SERVICE BULLETIN: 08JULY2025
DCE-05 S3 Beam Bracket Kit
 SB-DCE-05 S# Beam Bracket Kit

You may experience deflection on the lower cylinder mount cross beam under maximum platform capacity on a DCE-05 S3

DETAIL A
SCALE 1 : 4

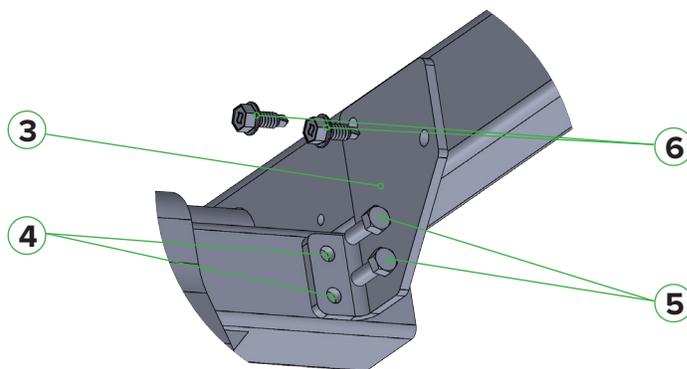
3. Place the right bracket in the correct spot. Using a C-Clamp if possible.
4. Mark the 2 holes on the cylinder mount cross beam using a marker. Then drill two holes on the cylinder mount cross beam with a 3/8" drill bit.
5. Place the bracket and insert the two 3/8" bolts with Red Loctite into the cylinder mount cross beam and tighten using the flanged nuts.
6. Use two self-tapping bolts to secure the bracket to the adjacent scissor beam.

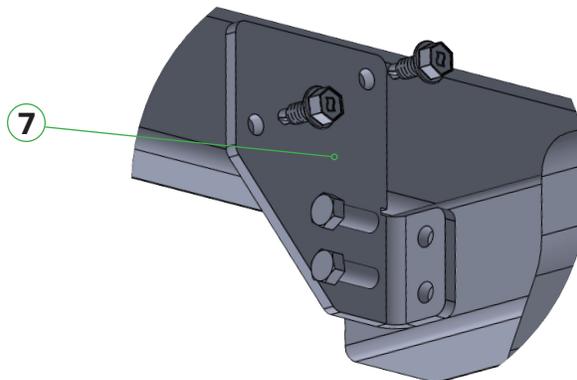
7. Place the left bracket in the correct spot. Using a C-Clamp if possible.

8. Repeat steps 4 through 6 for the left side.
